**CITY OF OLYMPIA**  
**Olympia Design Review Board**

**CONCEPT DESIGN REVIEW**  
**STAFF REPORT**  
**December 14, 2017**

**Project Name/Number:** Dockside Flats, Project No. 17-4634

**Location:** 210 State Avenue NW

**A100**  
 SITE PLAN

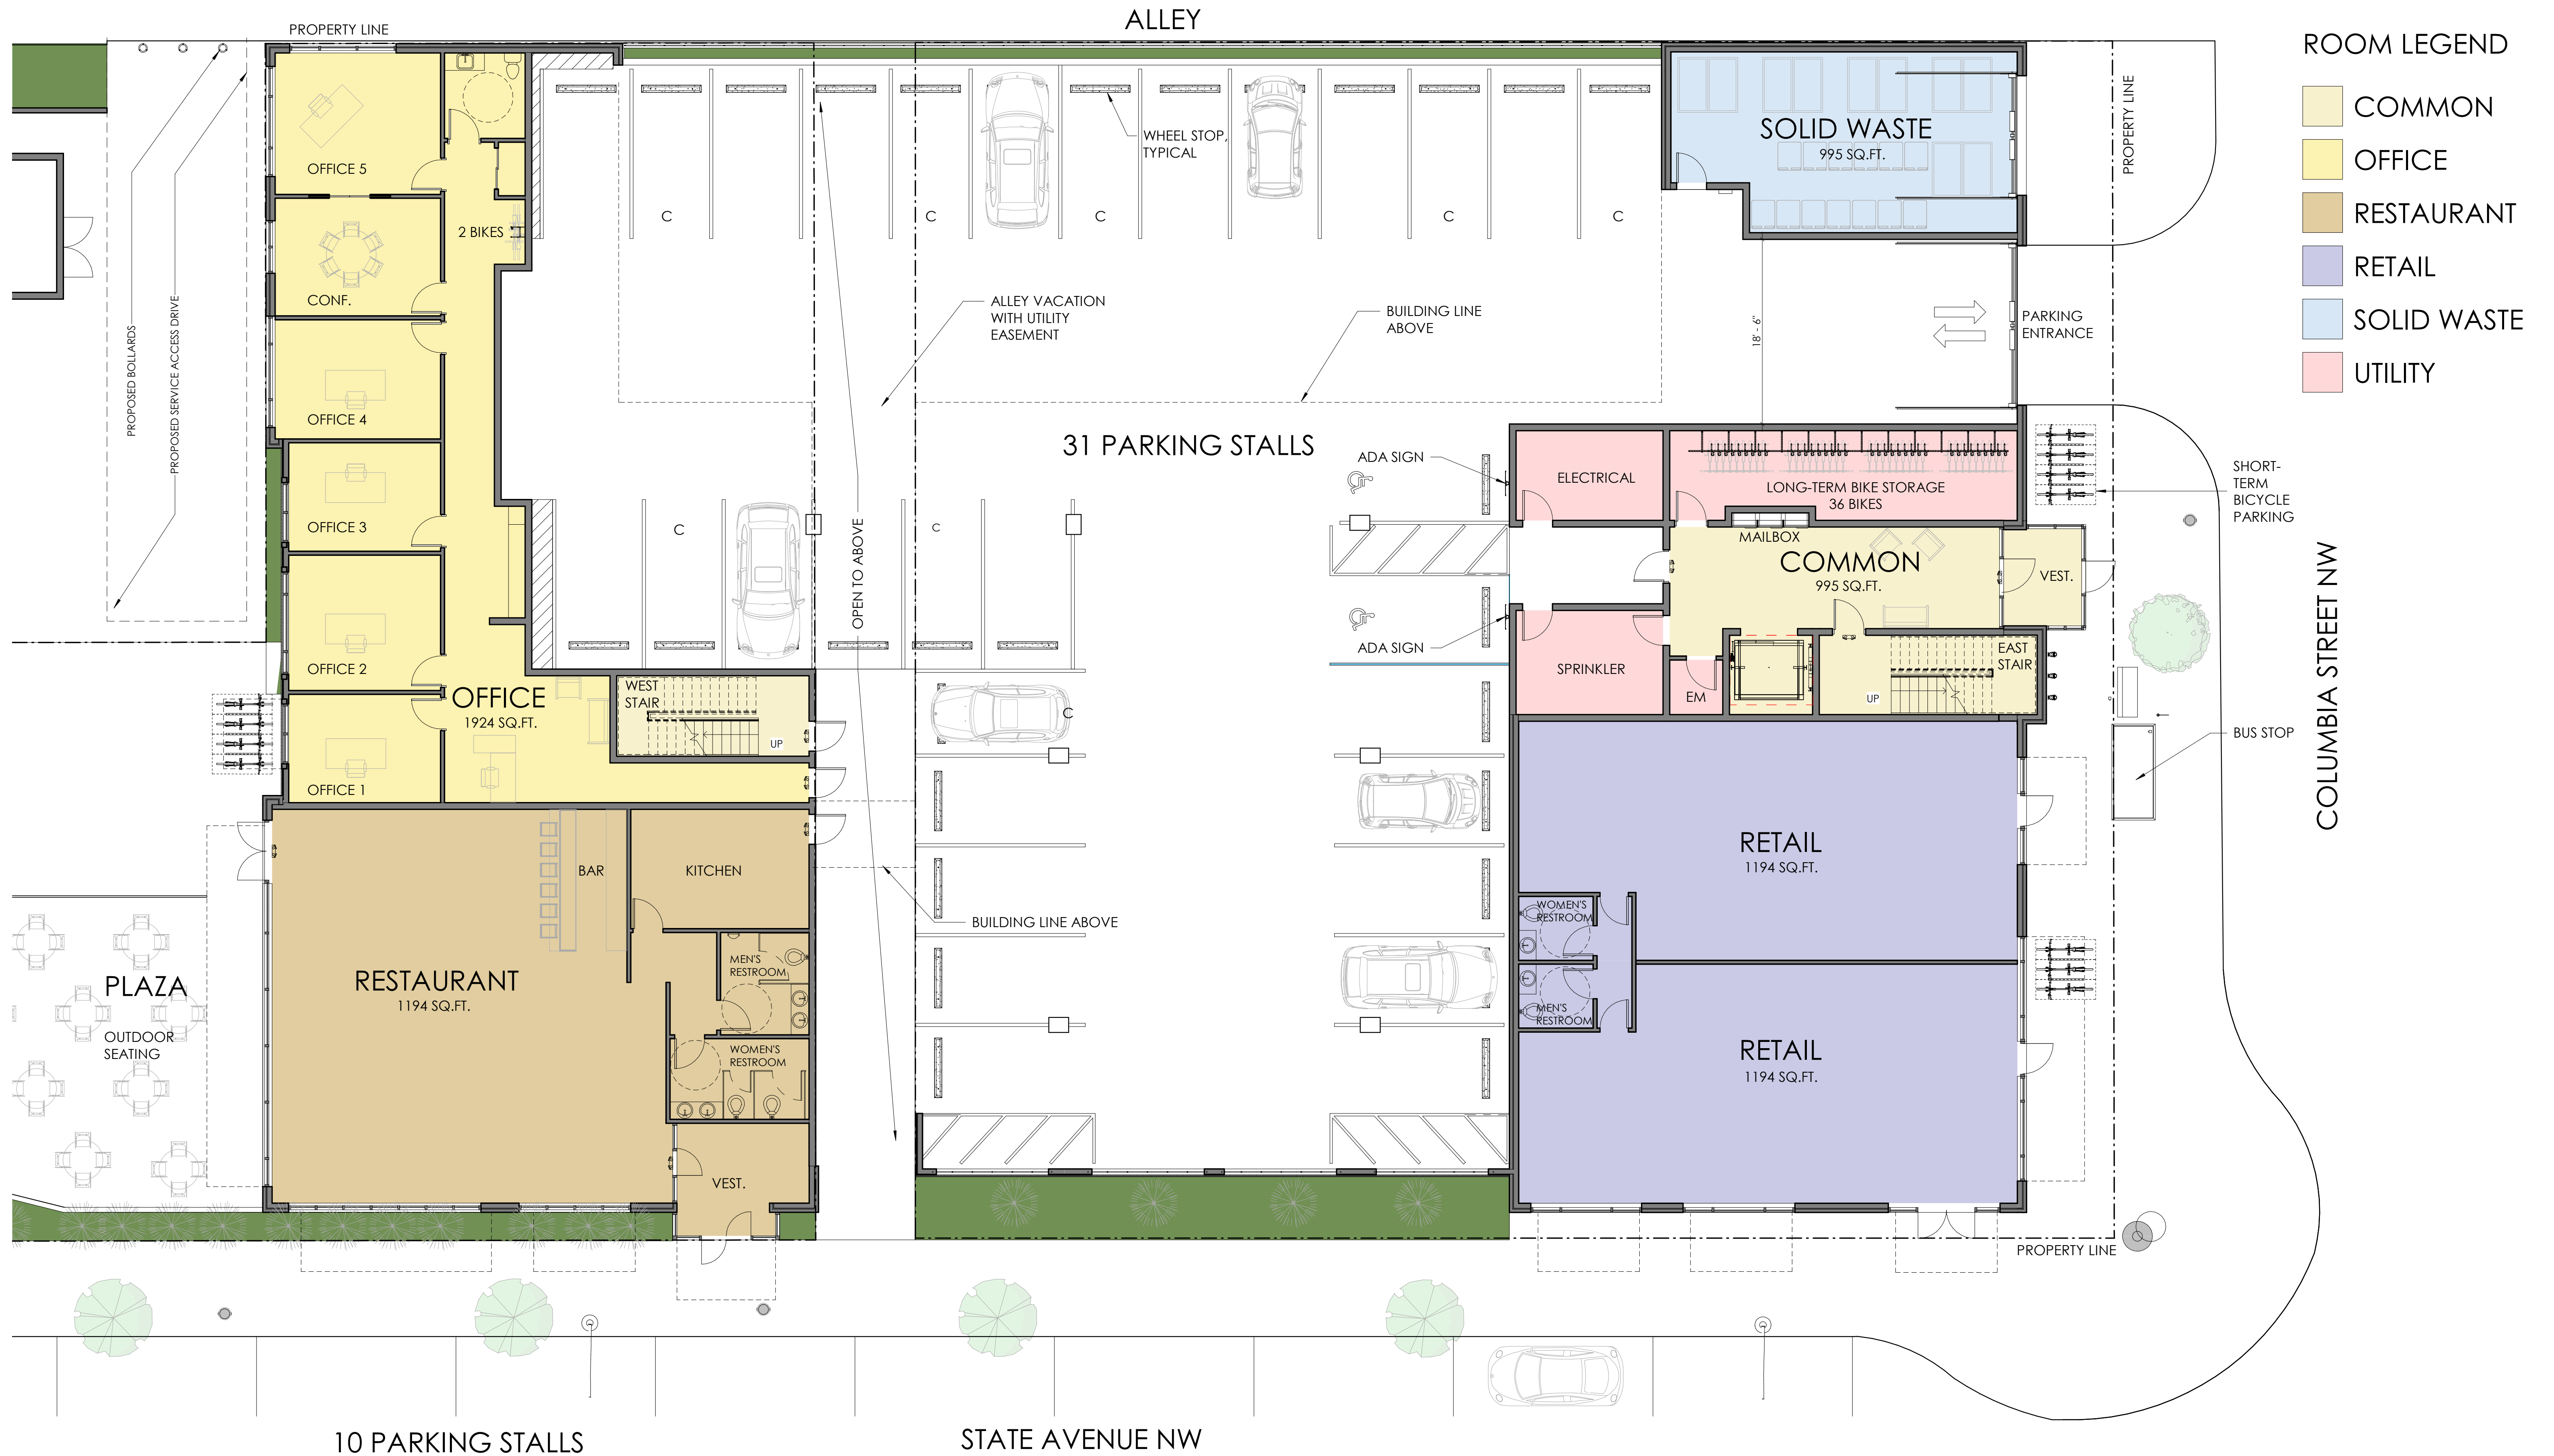
As shown on the site plan (page A001, Attachment 4), no portion of the building sits directly over the alley/sewer line. Instead, this area will be used as pedestrian access to and from the parking area, with the second and third floor corridors spanning this easement (see page A102, Attachment 4).

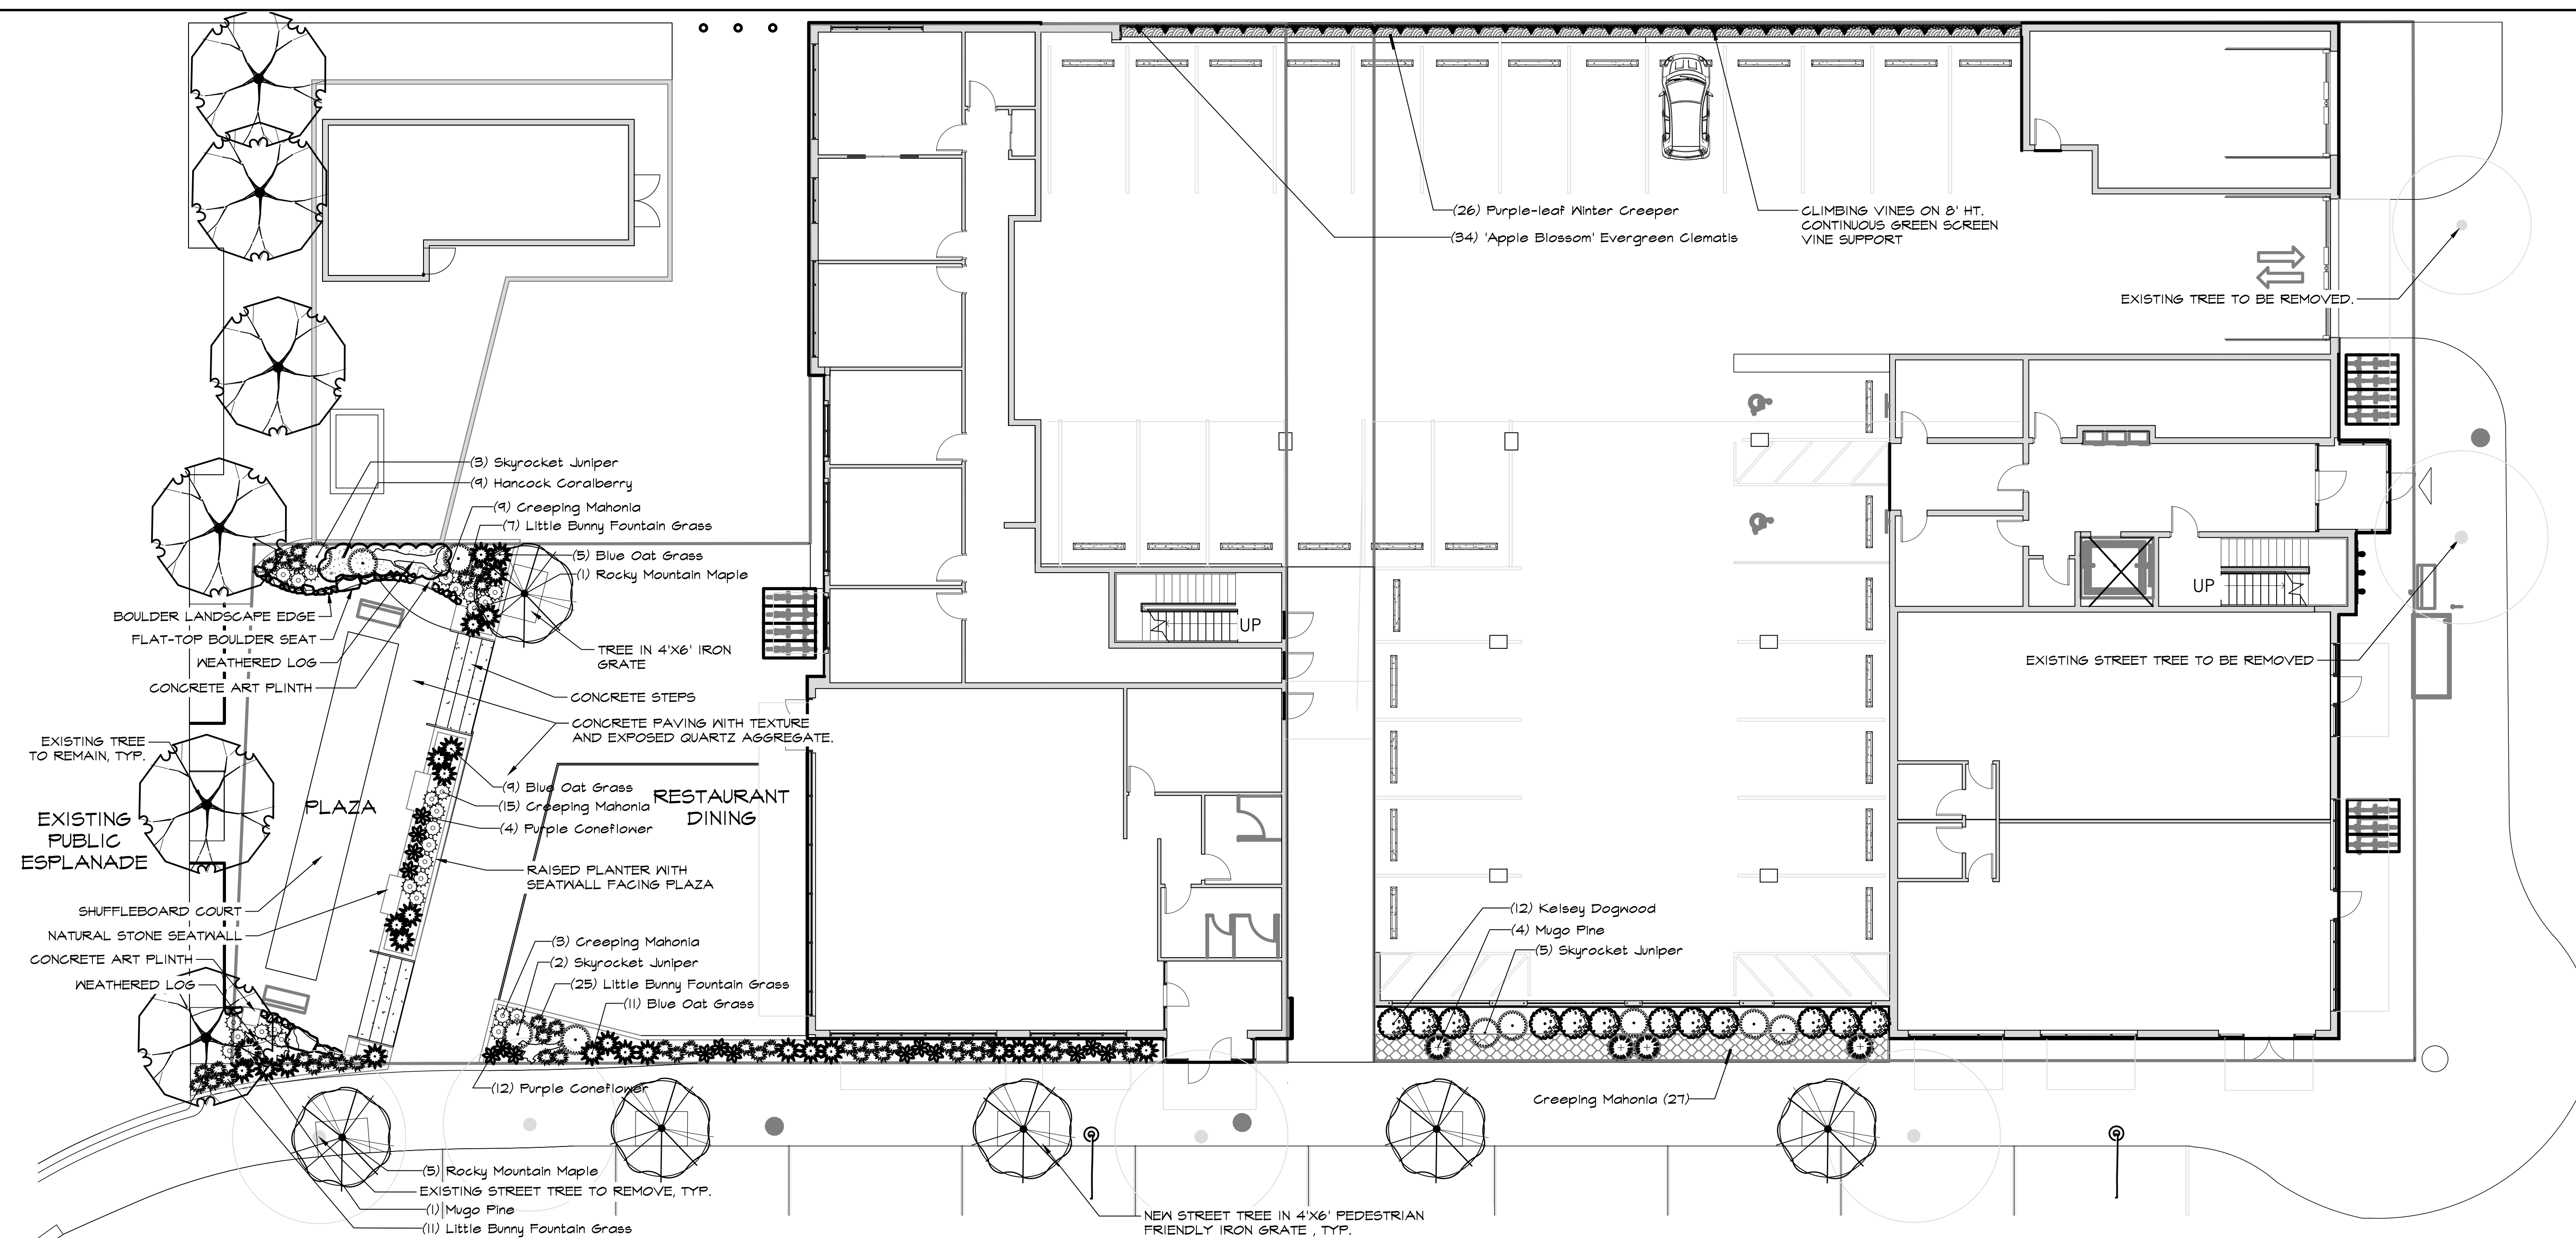
- *Except for the Skyrocket juniper, plants in front of the openings on the south side of the building are low growing. Greater screening can be achieved with the addition of climbing vines;*

- Skyrocket juniper can grow to 20' tall, which will be taller than the second level balconies. Unless it will be pruned, a shorter tree would be more appropriate;
- If space allows, add planting beds at the corner of State and Columbia;
- Add street trees along Columbia Street;
- Use larger street trees -- as large as possible given their proximity to power lines; and
- Use containers/pots along storefronts to offset absence of perimeter landscaping.

2. Provide an alternate paving pattern/texture between the roll-up doors and curb along Columbia Avenue. *OMC 18.120.110*
3. Revise the landscape plan to address the following:
  - a) Unless the Skyrocket juniper is going to be pruned, replace with a smaller tree;

- b) Add climbing vines to the metal trellis on the south side of the building;
- c) Add street trees along Columbia Street;
- d) Use larger street trees (as large as possible in close proximity to power lines); and
- e) Provide additional landscaping, for example, planting beds at the intersection of State Avenue and Columbia Street, and containers and/or pots on the east side of the building.
